To Update Bescodyne Clutch/Brake Units from Single to Double Air Flow Valve

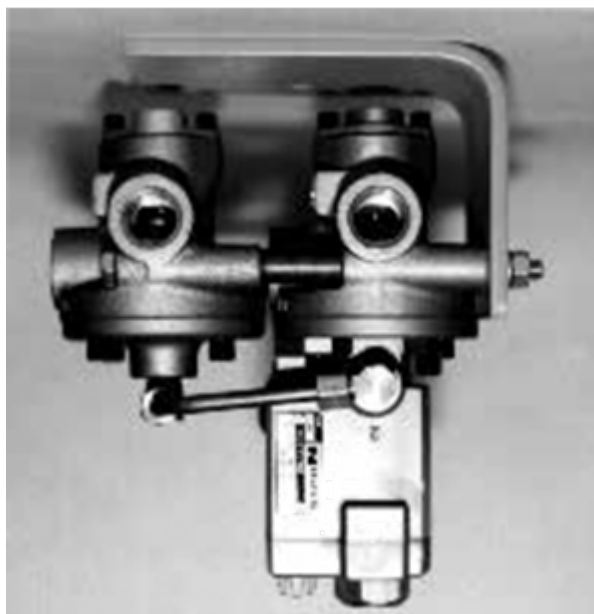
Besser has parts available to update your air valves to this NEW VALVE which allows operators to independently adjust the air pressure on the Clutch/Brake of the Bescodyne Drives. Simply replace the single air flow valve No. 107616 Ross Valve - 4 Way Directional Control, with the NEW DOUBLE AIR FLOW VALVE No. 103916.

The combination poppet valve assembly No. 103916 contains two valves: one No. 105463 Ross Valve (3WNC-Solenoid Operated - 1/2" NPT 2773A4914), and one No. 105464 Ross Valve (3WNO-Air Operated - 1/2" NPT 2754A4011).

<u>PART NO.</u>	<u>PCS.</u>	<u>DESCRIPTION</u>
103916	1	Combination poppet valve assembly
107963	1	Regulator
086718	1	Adapter
106152	1	Gage
090776	1	Nipple - 1/2" Close
090788	1	Tee - 1/2" Pipe
090689	1	Stree Ell - 1/2" Pipe
